RAMP REPORT REGION 2 ADA 2026

Route 7 – Vine Street
Belfast

CR13576

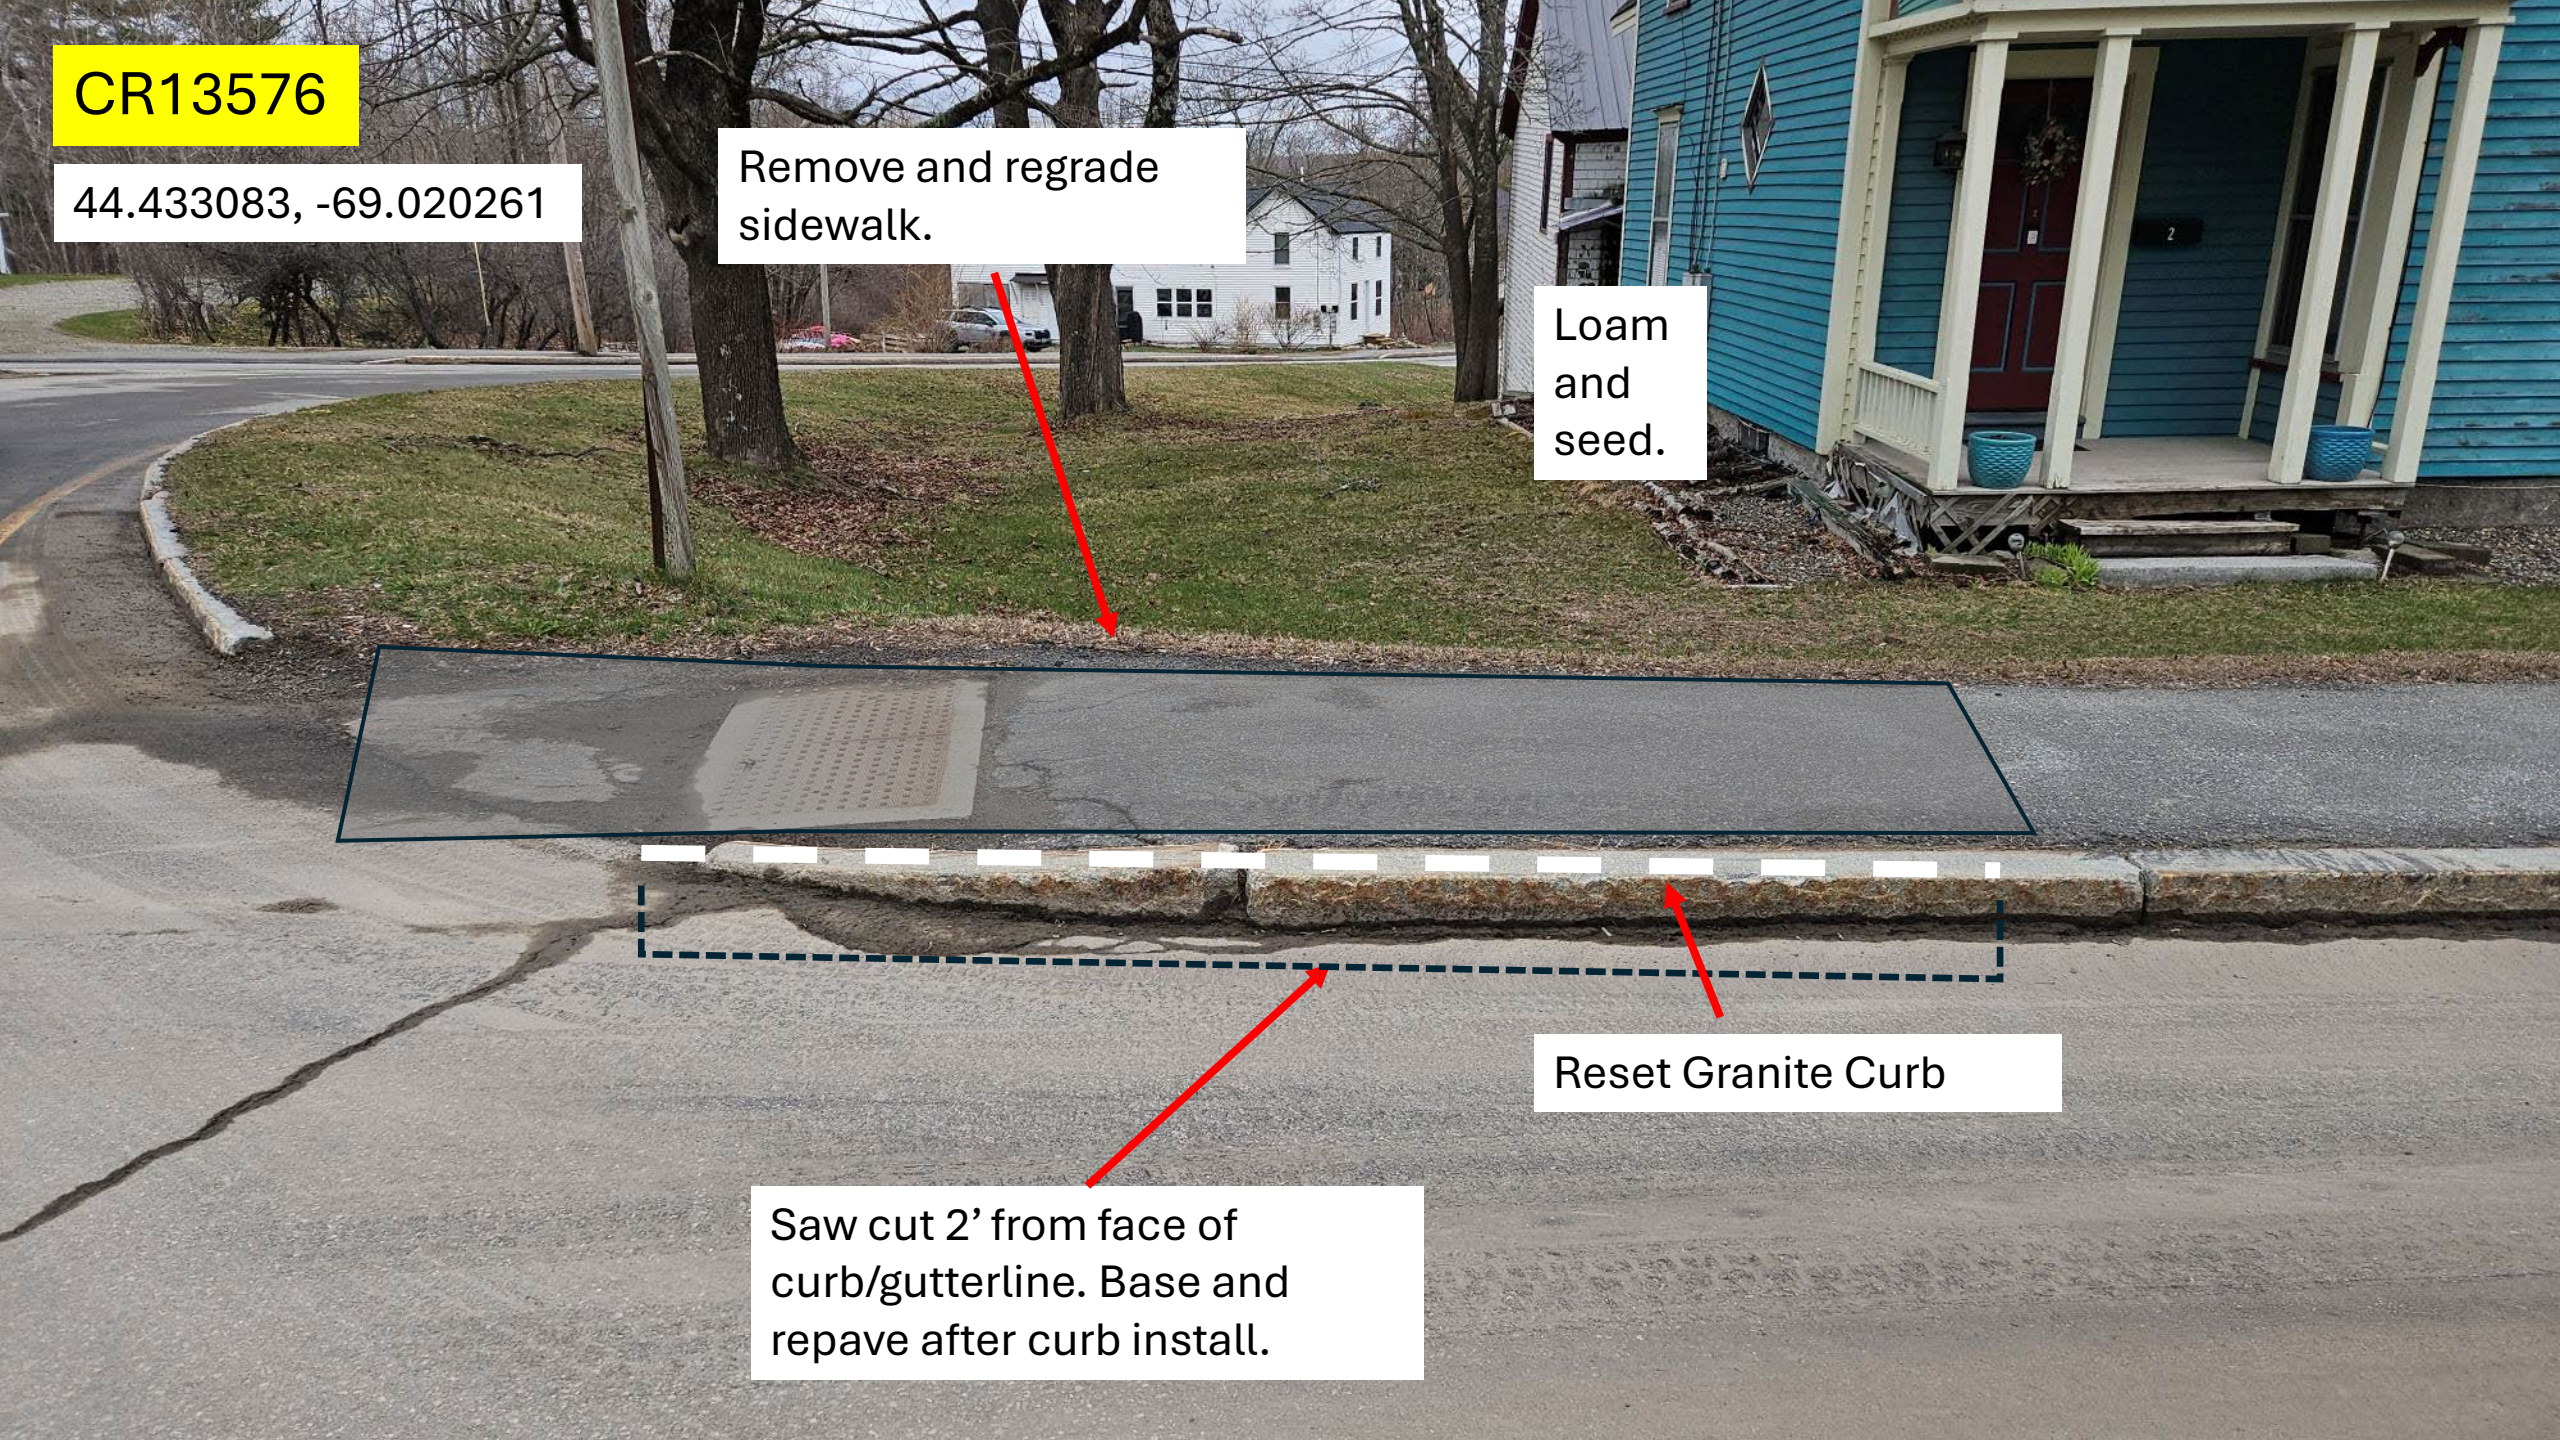
Remove and regrade
sidewalk.

Loam
and
seed.

Reset Granite Curb

Saw cut 2' from face of
curb/gutterline. Base and
repave after curb install.

CR06530

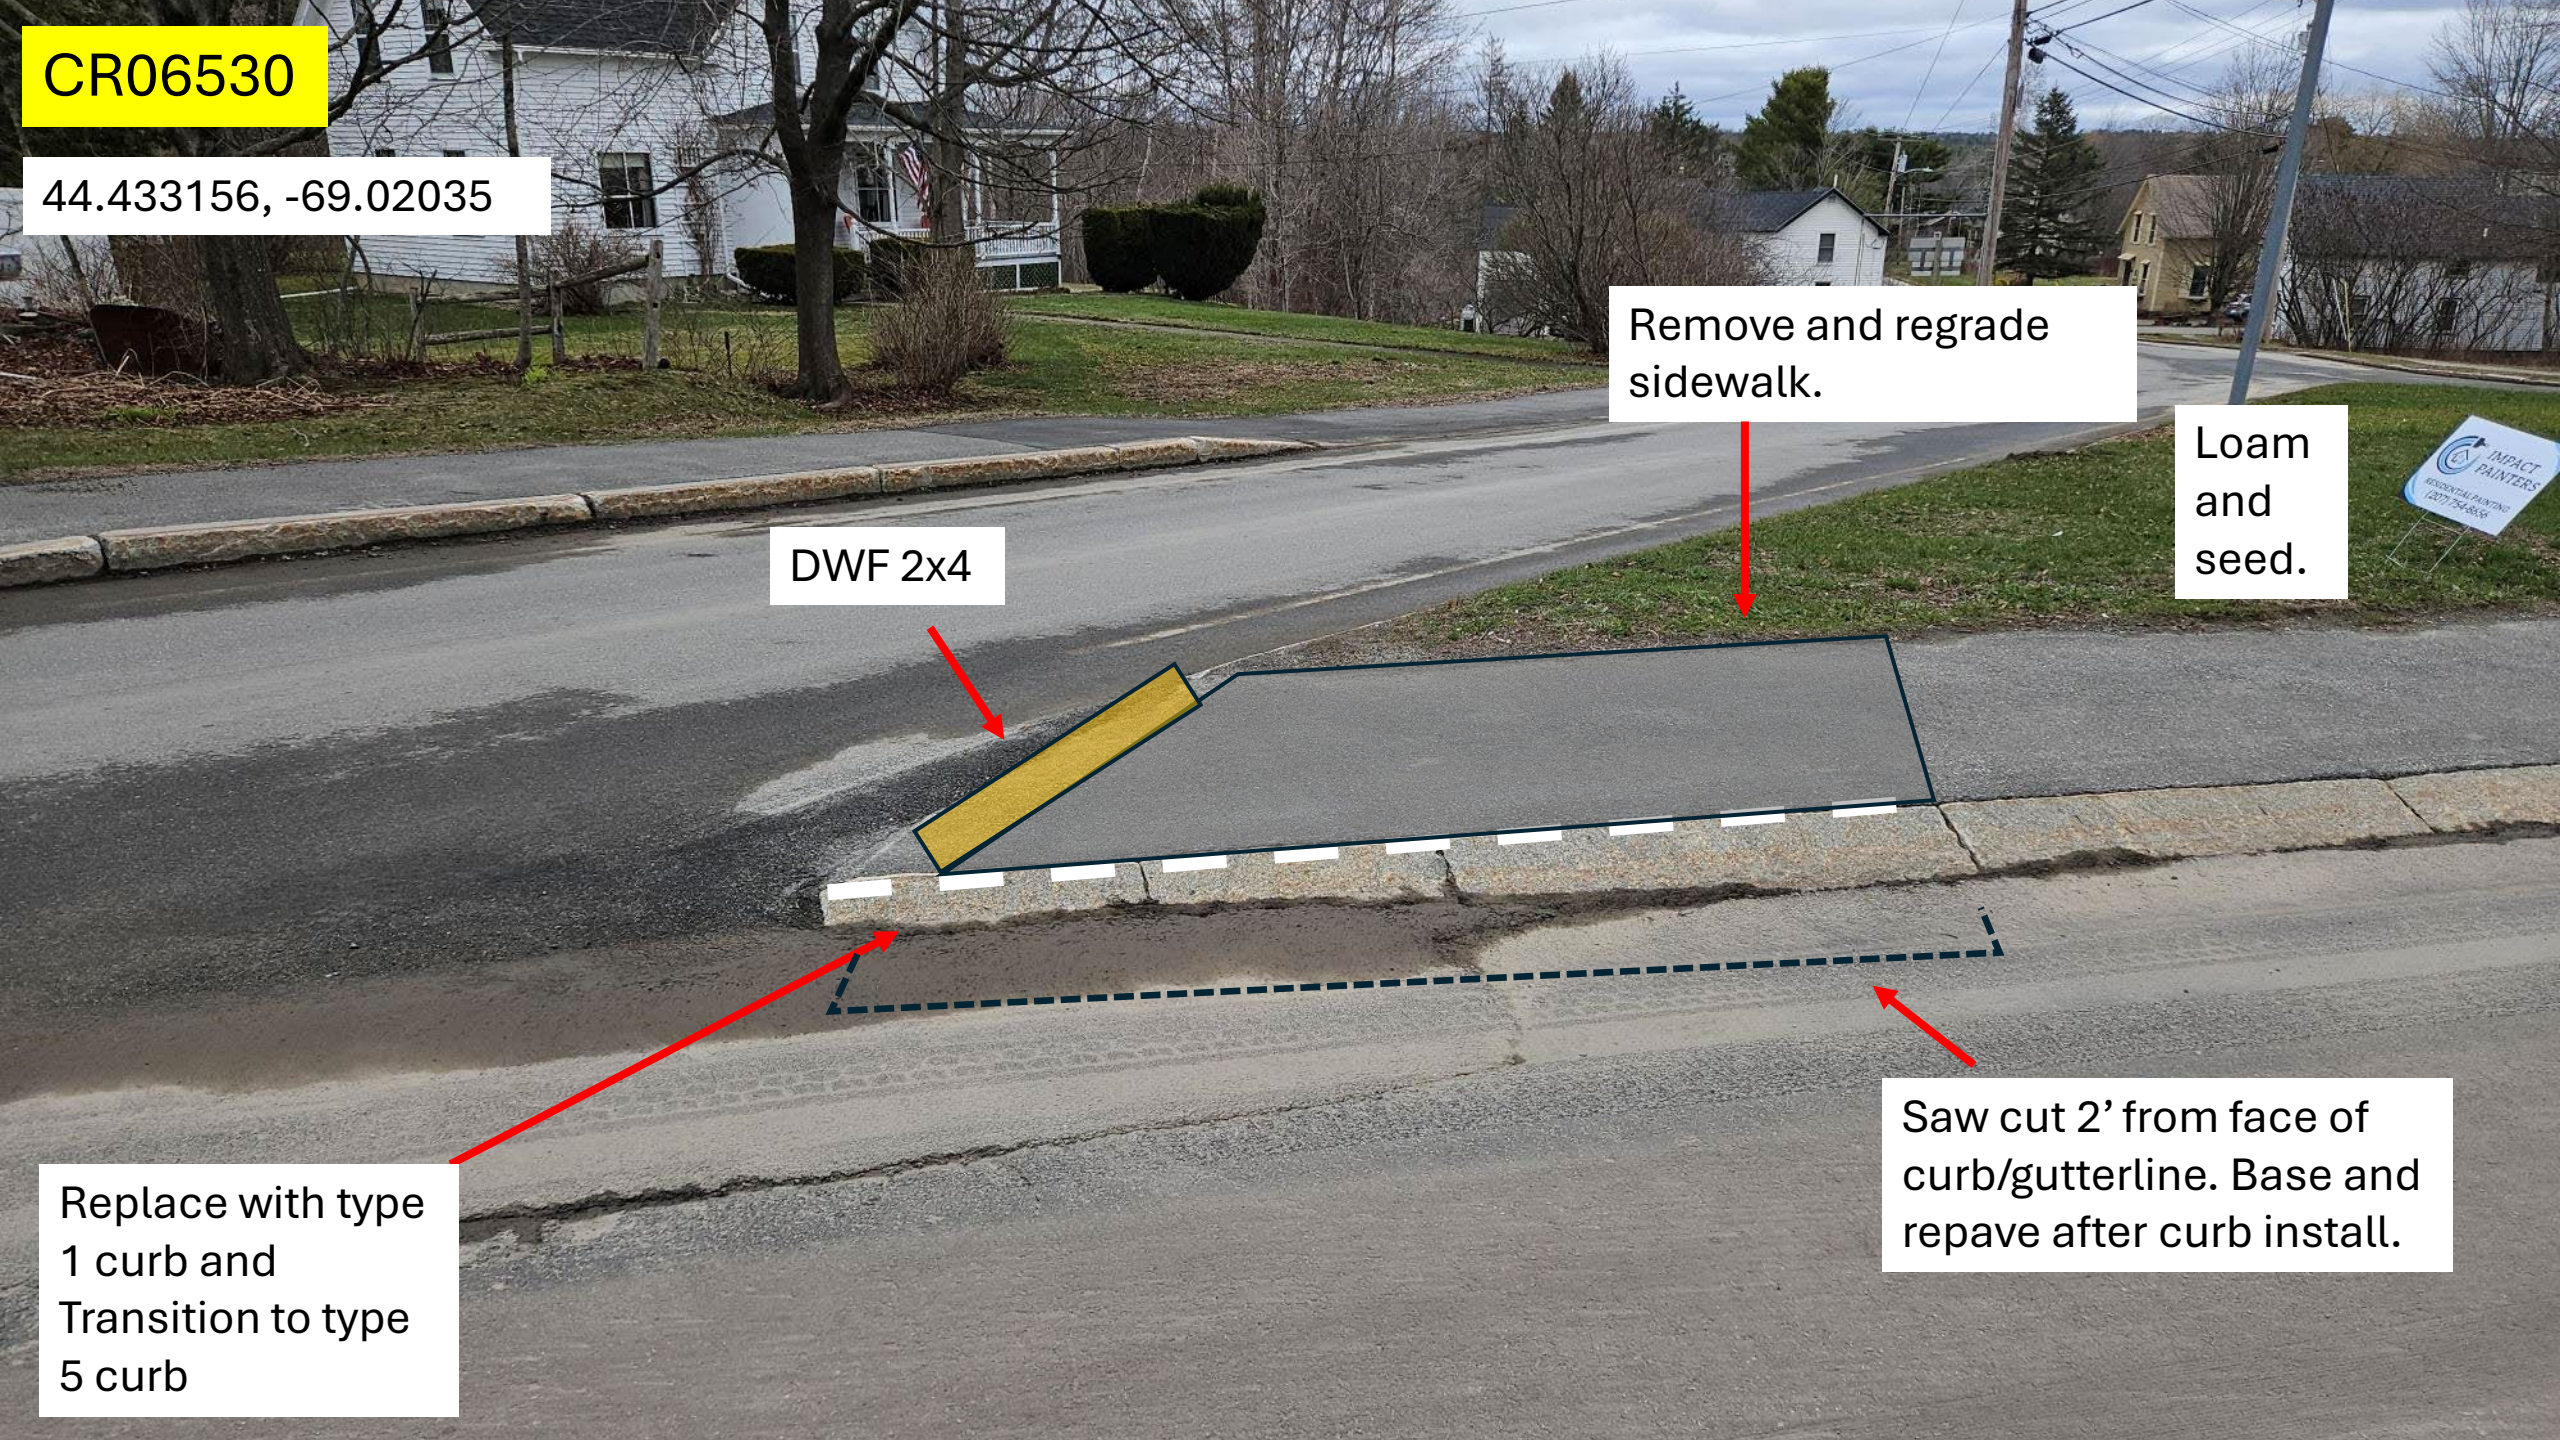
Remove and regrade
sidewalk.

Loam
and
seed.

DWF 2x4

Replace with type
1 curb and
Transition to type
5 curb

Saw cut 2' from face of
curb/gutterline. Base and
repave after curb install.

CR06532

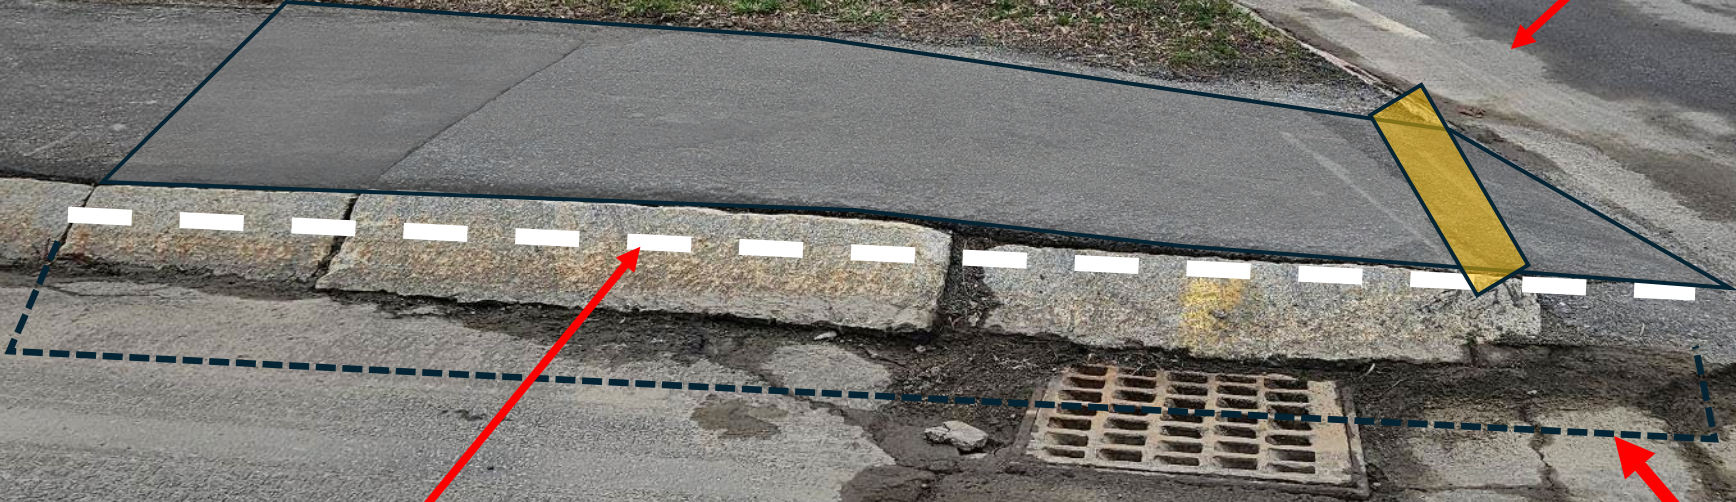
Remove and regrade sidewalk.

Loam and seed.

DWF 2x4

Replace with type 1 curb and Transition to type 5 curb

Saw cut 2' from face of curb/gutterline. Base and repave after curb install.
